Response to reviews of *High-Resolution Continuous Flow Analysis Setup for Water Isotopic Measurement from Ice Cores using Laser Spectroscopy* by Emanuelsson, et al., AMTD 7 12081-12124, 2014.

We appreciate the constructive comments from two anonymous reviewers. We address their comments one by one below. Reviewer comments are in red, our responses are in black and changes to the revised manuscript are in blue.

Figure AR1. Shows δ -CFA data from a response time test performed by a switch in water standards at the melt head (blue dots), a LSO fitted curve (black line) and the 5% and 95% of change of the response (response time red line) for the custom 2014 setup.

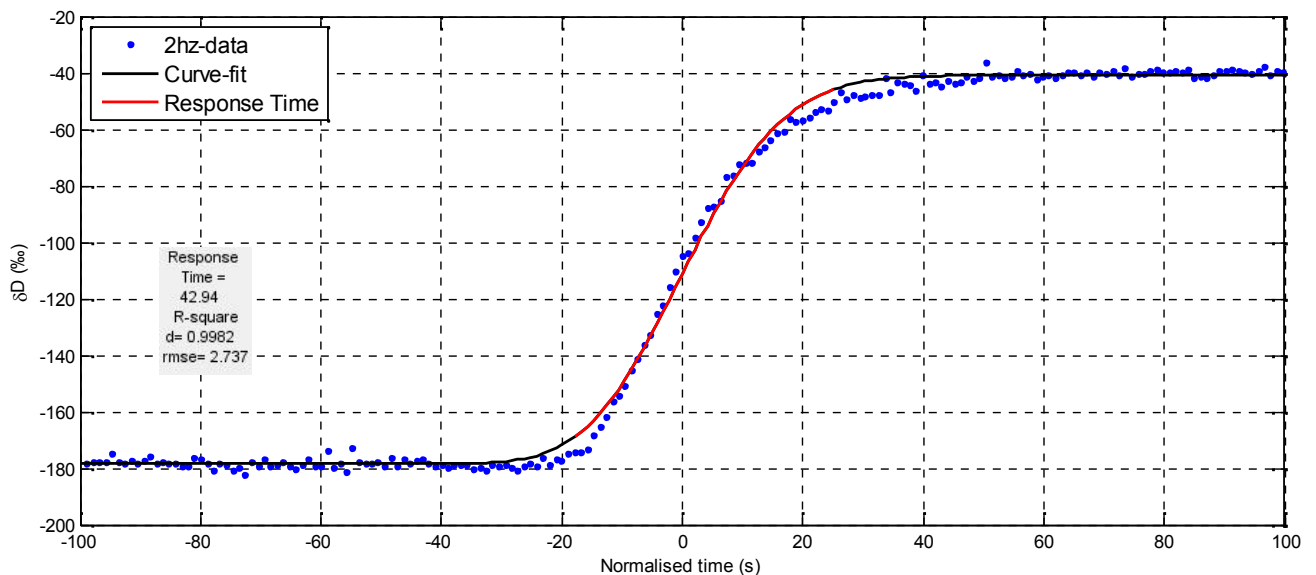
1) Characterisation of the response time of the full continuous flow analysis (CFA) system as already discussed in Gkinis, et al. 2011 for a full characterisation of the CFA-IWA system a step change in the water isotope composition should be done at the melt head to fully characterise the presented system.

Such an experiment may be beyond the scope of this publication but it should be discussed why this has not been done. Would it be possible to construct an artificial ice core with several distinct layers from different standard waters, so that the step change is introduced at the very beginning of the whole setup, i.e. at the ice melting unit?

The reviewer raises a valid and important point. We did perform an experiment to assess the response time via the entire CFA system. However, this experiment was very limited and only performed at the very end of the CFA campaign because there was concern that our water standards of different isotopic compositions (Table AR2) could contaminate some analyses, particularly for trace element concentration measured by ICP-MS. This contamination would have been a concern for all equipment upstream of DB1 (Fig. 2). As a result, we were only able to measure the response time from the melt head by applying a stream of liquid water of different compositions directly to the surface of the melt head, rather than a synthetic ice core with layers of alternating isotopic compositions. This experiment was only carried out at the end of the 2014 campaign, and never during the 2013 campaign.

In answer to the reviewer’s question, we present the data from our limited experiment here as Figure AR1, below. The data suggests that when a step change between water standards was performed at the melt head, the response time was 43 s. This can be compared to 19 s when performed at the multi-port valve (V2). The difference between the two estimates indicates that the δ -signal is smoothed between the melt head and the valve. The discrepancies between the data and the fitted curve suggests the response may be more complex than the fitted model, with ~70% of the response occurring more quickly, and the final portion of the response occurring more slowly than expected based on the fit for the 43 s response time.

The purpose of this manuscript is to characterize the isotope measurement system rather than the full CFA set up. Therefore, given the reviewers comment, we propose that it is appropriate to insert only a brief comment at the end of the section acknowledging that:

“To conclude discussion on this topic, we note that the response times reported above do not represent the full response time of the entire CFA system, as measured from the melt head. Limited experimentation produced an estimate of ~43 s for the response time of the entire 2014 CFA system. This is more rapid response than all systems reported in Table 3 except the Custom 2014 setup. Thus, to take full advantage of the fastest response times, the isotope analysis system could be placed closer to the melt head by changing the overall CFA design, or shortening the sample line between the melt head and DB1.”

Figure AR2. Comparison between the WVISS and the custom 2014 setup, the figure shows the differences in response time and memory effects between the setups.

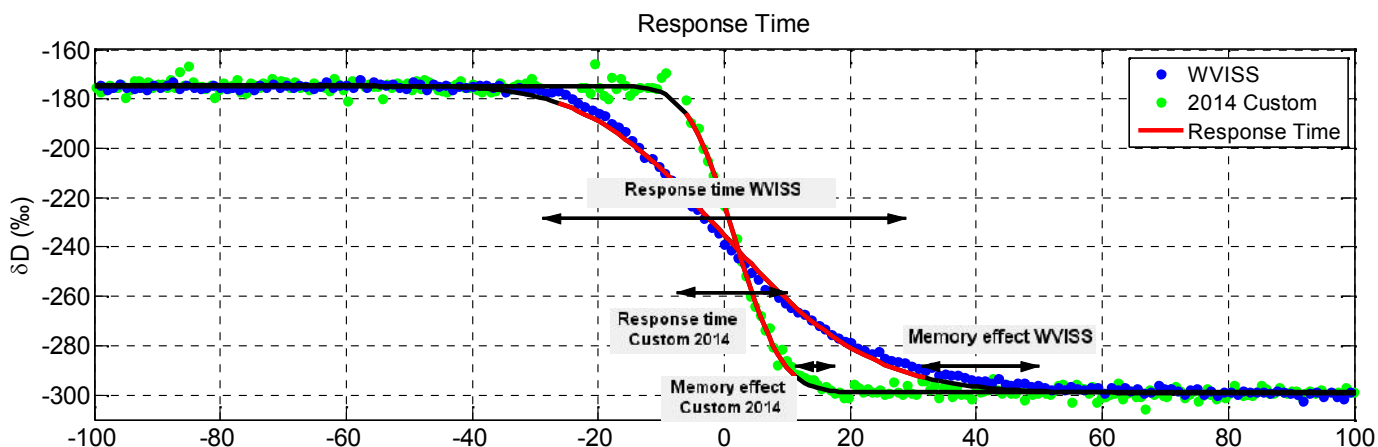
- Abstract: p. 12082 L. 15 The authors say « Another improvement... is that the modified setup has a reduced memory effect », is that really another improvement? To me this is not another result and simply comes along with the response time reduction.

We have used a cumulative log-normal distribution to describe the transitions between waters with known isotopic composition. This choice of function was introduced by Gkinis et al. (2010) and allows us to empirically fit data that shows true dispersion (represented by the cumulative normal (Gaussian) distribution, as reported in Gkinis et al. (2011), as well as a reservoir or memory effect, which would add an exponential response curve to that derived from dispersion. We empirically define a memory effect as causing an asymmetric tail in the last 5% of the step in δ values, with an extended tail compared to our empirical fit. For the purposes of this study, this definition of a memory effect appears to be useful in that it clarifies memory effects that are problematic from a practical and analytical perspective.

We can clarify this further graphically. We distinguish between the response times, which we call the fast response (red curve fit in Fig. AR2), and memory effects, which we call the time it takes to reach the final isotopic value at the end of the transition (Fig. AR2). The reservoir effect due to the large volume of the vaporizer chamber in the WVISS is one example of a memory effect. It is identifiable, but not large.

We propose to address this issue by reordering the list in the abstract and introduction to group the response time and memory effects together as items (2) and (3) rather than (1) and (3). We then define the memory effect after discussing the response times, as follows:

“Alongside the response time, we define a memory effect as causing an asymmetric tail in the last 5% of the step in δ values, with an extended tail compared to our empirical fit. Avoiding memory effects is desirable given the large range of δ in ice cores and in the standards required for normalization.”

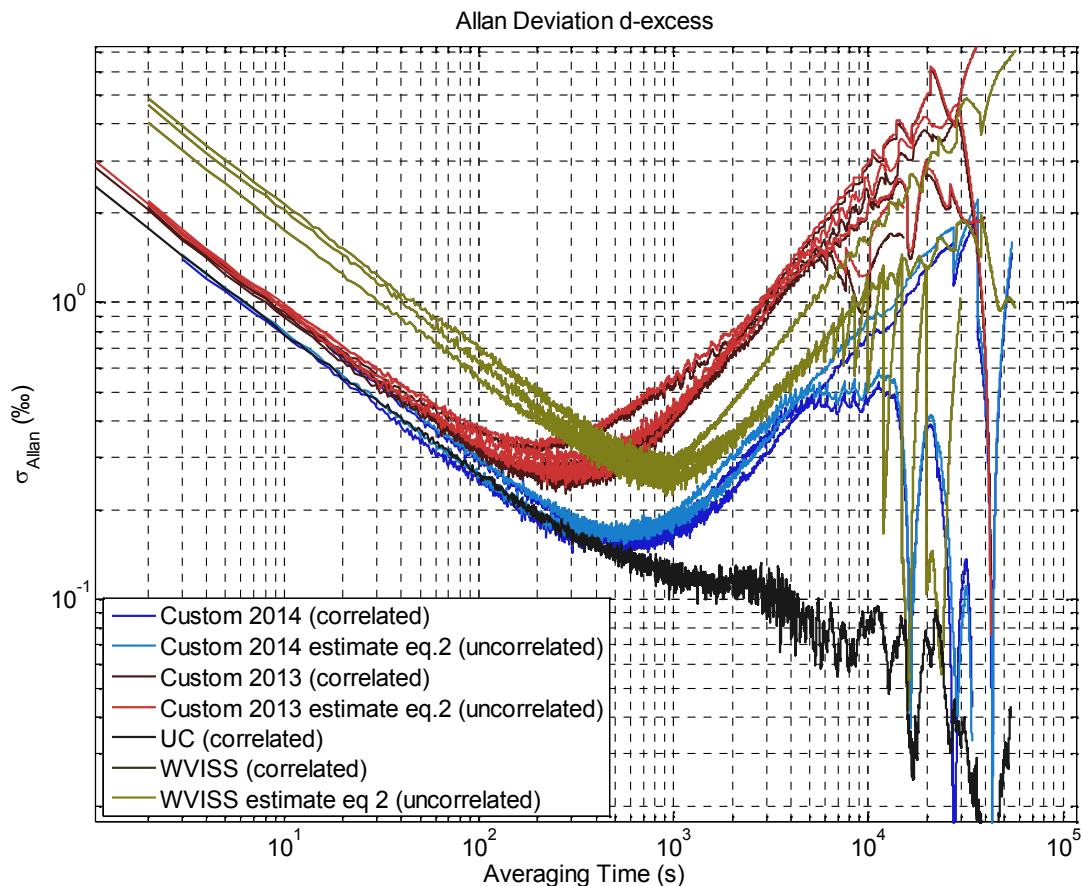
- Results and Discussion Eq. 2: I don't think δD and $\delta^{18}O$ measurements are uncorrelated. If they are correlated you probably underestimate the error with this equation.

The reviewer is correct to identify that Eq. 2 assumes that the δD and $\delta^{18}O$ measurements are uncorrelated, and this has been a useful point to examine. We are aware of and have reviewed the literature on the derivation of this formula, which can include a term to adjust for correlation. We clarify that the key assumption is that the δD and $\delta^{18}O$ measurements are uncorrelated as a result of instrumental noise that we expected to occur in 15 s averages of measurements from analysis on a single water standard. We do not recommend thinking of the correlation as that which occurs while running analyzing an ice core, within which the two isotopes are correlated along the local meteoric water line. We have used our data from measurements on a single water standard (LHW) for extended time periods to check that this assumption is valid. By examining 15 instances of long runs on this single standard, we found only 3 instances where some aspect of measurements (with a 15 s moving average applied) showed correlation coefficients (R^2) > 0.3 in δD and $\delta^{18}O$ (due to drift).

To further investigate this approach, we have confirmed that it is valid by using our long-term stability tests to calculate Allan variance plots of d-excess, and using Eq. 2. Thus, in one approach we use the $\delta^{18}O$ and δD co-varying raw-data measurement to generate a d-excess time series. In this method, the d-excess Allan deviation curves are derived using the d-excess time series (darker color in Figure AR3) resulting from the actual co-varying $\delta^{18}O$ and δD ; we refer to this estimate as “correlated”. In the second approach (referred to as “uncorrelated”) d-excess Allan deviation estimates are calculated from $\sigma_{Allan, \delta^{18}O}$ and $\sigma_{Allan, \delta D}$, using Eq.2. The uncorrelated estimate curves from Eq.2 with (lighter color in Fig. AR3) are located above the raw-data d-excess measurement curve for both the 2013 and 2014 custom setups, which shows that the error estimate using Eq. 2 is conservative and that we are not underestimating the error using this equation. The offset (noise canceling effect) between the correlated and uncorrelated curves increase with longer integration times for the custom setups, about 0.05‰ at peak uncertainty (1.2 h) for the custom 2013 setup, but can be larger during certain runs (0.1‰) where more drift is present and the correlation is stronger.

To address this comment, we propose to insert the following sentence:

“We note that Eq. 2 assumes $\delta^{18}O$ and δD are uncorrelated, which was verified to be true for the vast majority of our measurements on standards averaged at 15 s intervals.”

Additionally, we propose to include Figure AR3 in the Supplementary Material to the revised manuscript.
